APPLICATION NO.	FILING DATE	FIRST NAMED INVENTOR	ATTORNEY DOCKET NO.	CONFIRMATION NO.
10/820,372	04/08/2004	Hassan Asadi	4452-639	7627
27799 75	90 07/19/2006		EXAM	INER
COHEN, PONTANI, LIEBERMAN & PAVANE			WILLIAMS, THOMAS J	
551 FIFTH AV	ENUE		ART UNIT	PAPER NUMBER
SUITE 1210 NEW YORK, 1	NEW YORK, NY 10176		3683	
11211 10141, 1			DATE MAILED: 07/19/2000	6

Application No.	Applicant(s)	
	10/820,372	ASADI ET AL.	
Office Action Summary	Examiner	Art Unit	
	Thomas J. Williams	3683	
The MAILING DATE of this communication ap Period for Reply	pears on the cover sheet with the	correspondence address	
A SHORTENED STATUTORY PERIOD FOR REPL WHICHEVER IS LONGER, FROM THE MAILING Description of time may be available under the provisions of 37 CFR 1. after SIX (6) MONTHS from the mailing date of this communication. If NO period for reply is specified above, the maximum statutory period. Failure to reply within the set or extended period for reply will, by statut Any reply received by the Office later than three months after the mailing earned patent term adjustment. See 37 CFR 1.704(b).	DATE OF THIS COMMUNICATION 136(a). In no event, however, may a reply be time the second of the seco	N. nely fi

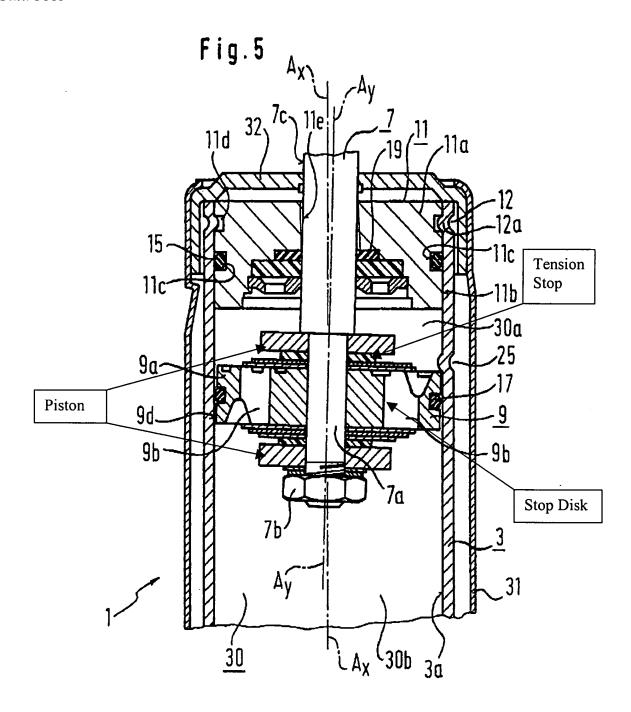
Re-claim 1, Kundmuller et al. disclose a piston cylinder assembly comprising: a cylinder 3 having a central axis Ax, the cylinder is fitted with a piston rod guide 11 and has an inner wall with a radially inward extending projection 25 adjacent to the piston rod guide on one side of the axis Ax; a piston rod 7 and a piston (interpreted as the plate like elements on either side of element 9, see figure below, this is consistent with instant figure 2) move along the axis, the piston has an outer diameter and carries a piston seal 17 (the piston is interpreted as supporting the seal and thus carries the seal, this appears consistent with the embodiment of instant figure 2) the seal 17 is in contact with the inner wall of the cylinder, the piston seal has an outer diameter, the piston and the piston seal divide the cylinder into a working space 30a on the piston rod side and a working space 30b away from the piston rod, the space is filled with a working medium; a stop disk 9a is mounted on the piston rod 7 axially adjacent the piston, the stop disk has an outer diameter greater than the outer diameter of the piston (see figure below), but smaller than the

outer diameter of the piston seal 17 (see column 6 lines 50-55), whereby the stop disk rests against the projection and the piston rod is tilted with respect to the axis such that working medium can escape around the piston during a fire, see figure 5.

It is noted that the instant invention defines the piston as being the plate like elements on either side of element 11. As such the interpretation of the prior art appear appropriate.

Re-claim 3, the stop disk is a component of a piston valve.

Re-claim 4, a tension stop is located between the stop disk and the piston guide assembly.

Re-claim 5, the tension stop is an elastomeric material.

Re-claim 6, the stop disk is spaced from the piston, the stop disk and the piston do not occupy the same space and are therefore spaced from one another.
